Re: Beevor Court, Barnsley

Further to our recent telephone conversation, please find below details of the proposed changes to the acoustic specification. This letter can be passed on to Sarah Newman in Environmental Health and Keiron Dunn in Planning to seek agreement to the change to the planning condition.

project: T4
 client: Yorkshire Housing
 drawing title: Location Plan
 scale @ A3: 1:1250 date: May 2008
 drawn: AM checked: AJH
 job no: 200957 drawing no: 200957-001
 issue status: Planning revision: P2

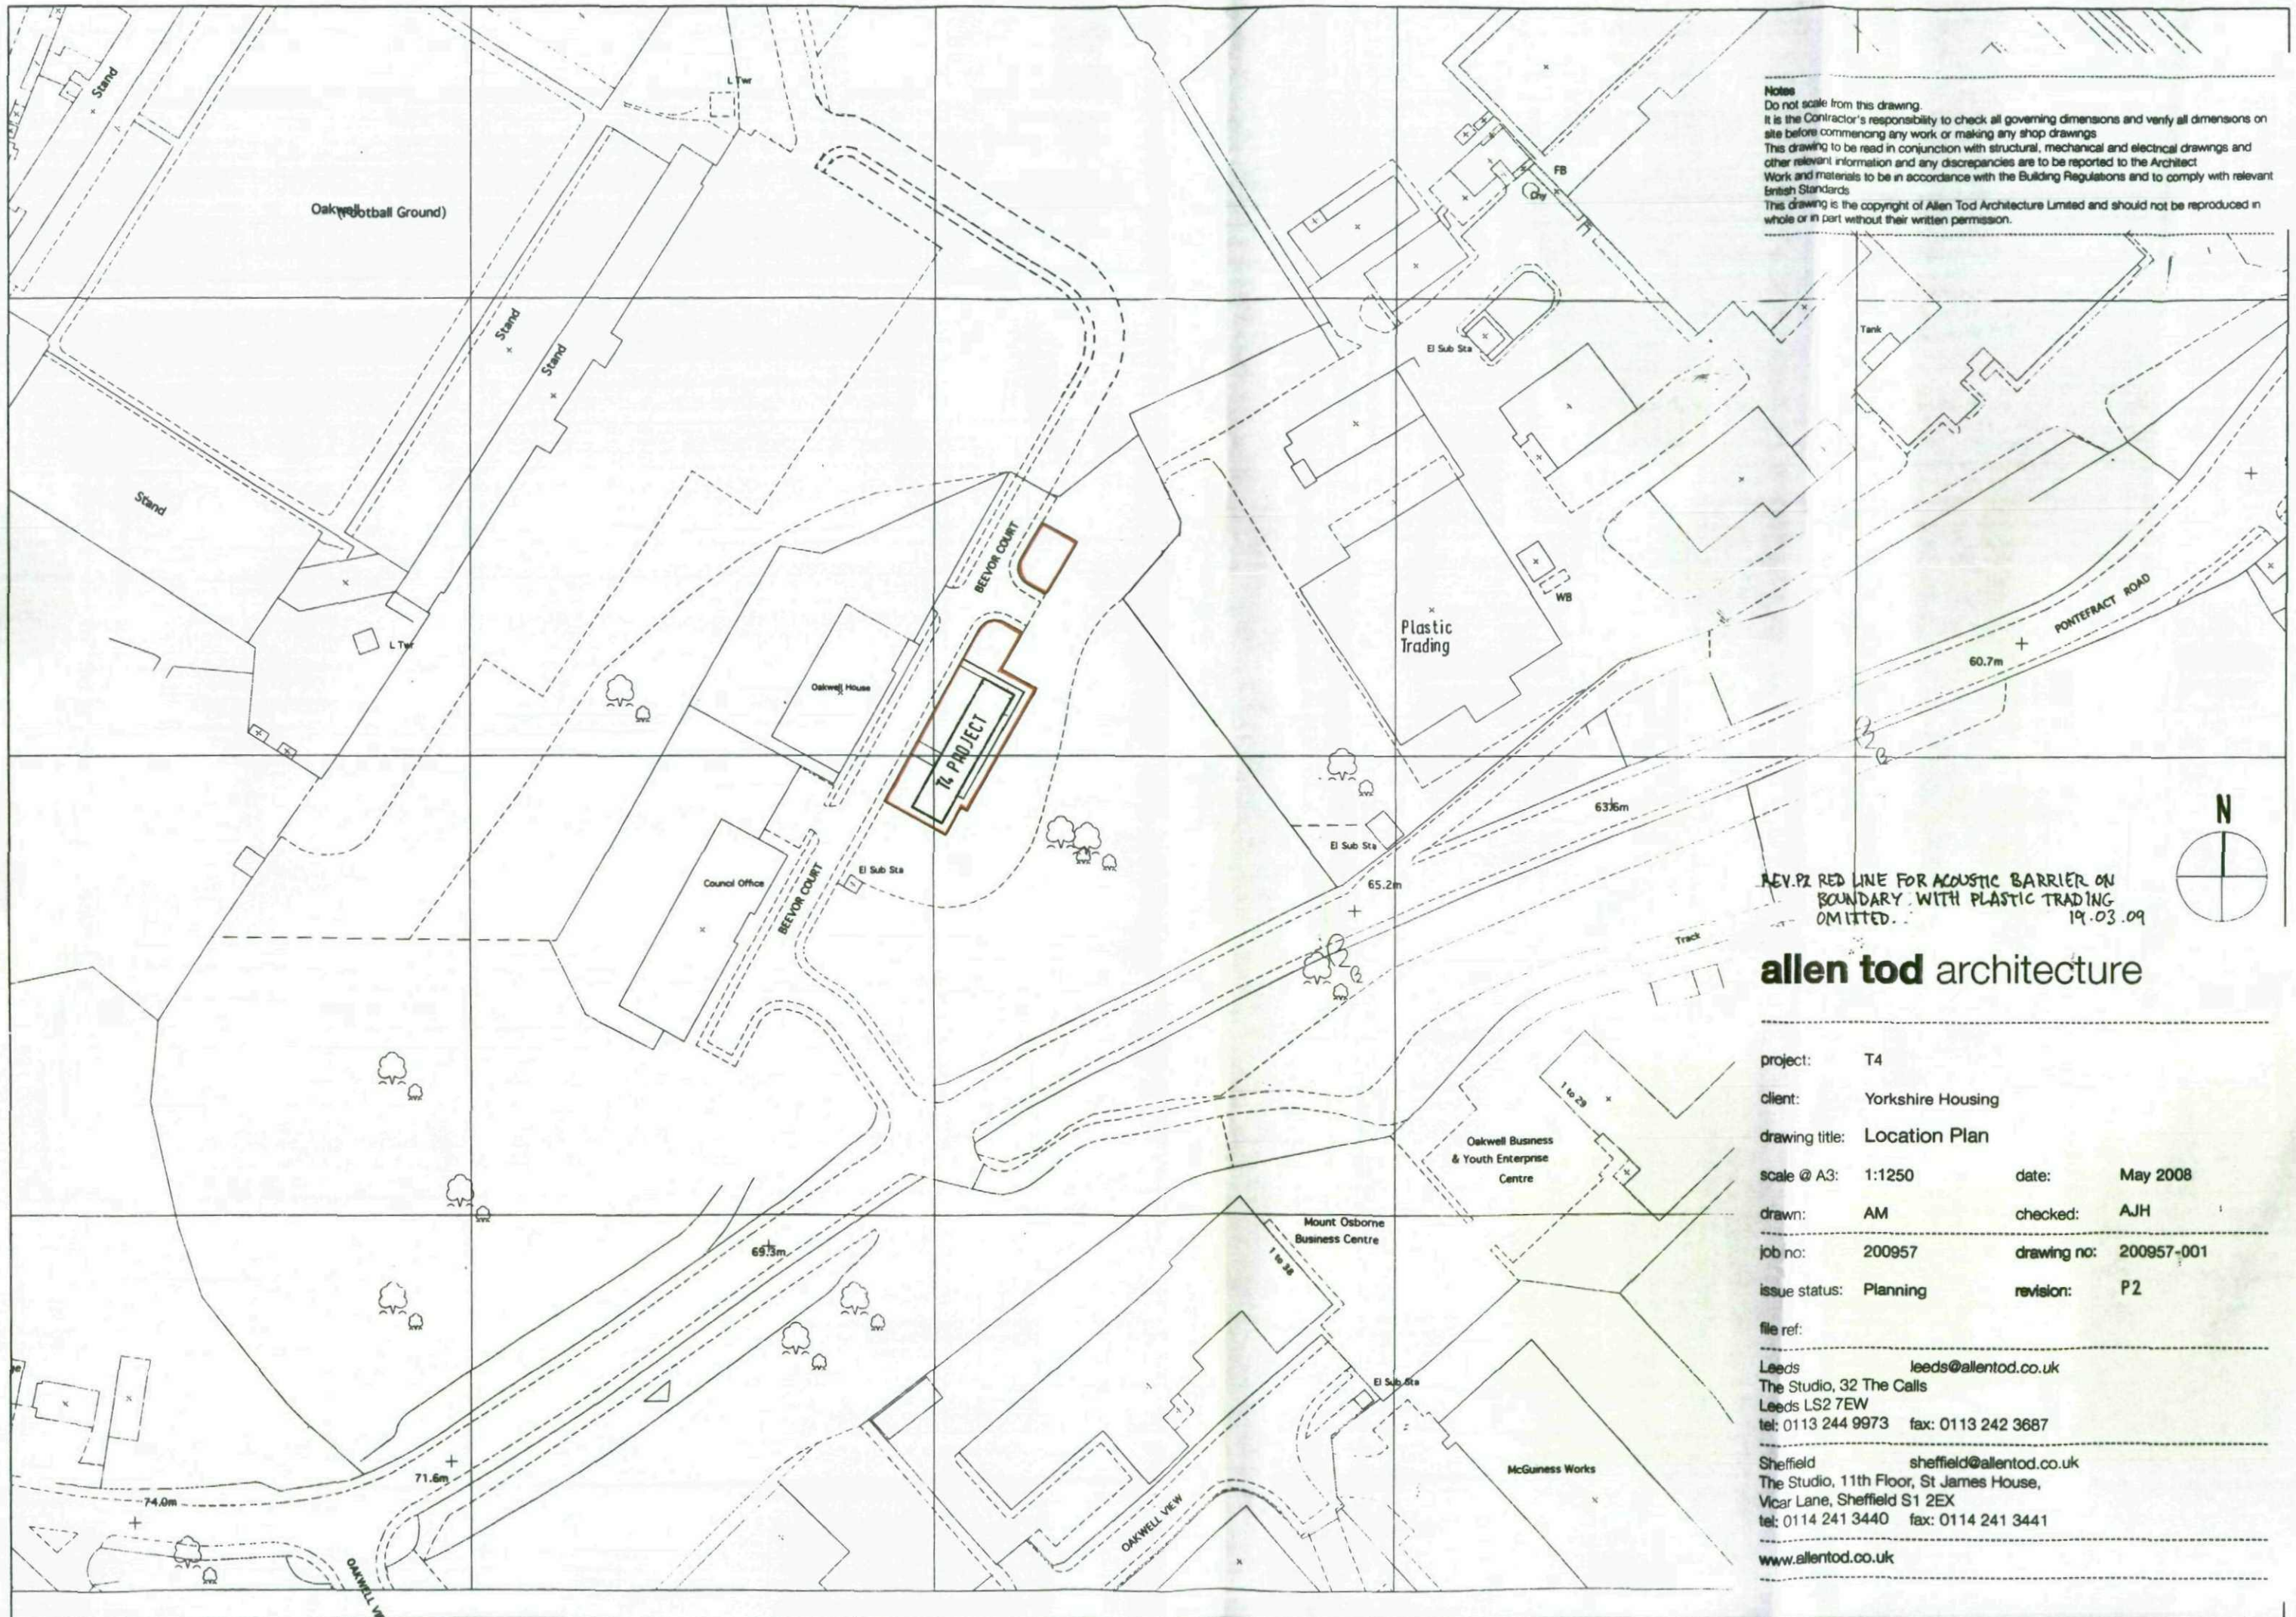
REV. P2 RED LINE FOR ACOUSTIC BARRIER ON BOUNDARY WITH PLASTIC TRADING OMITTED. 19.03.09
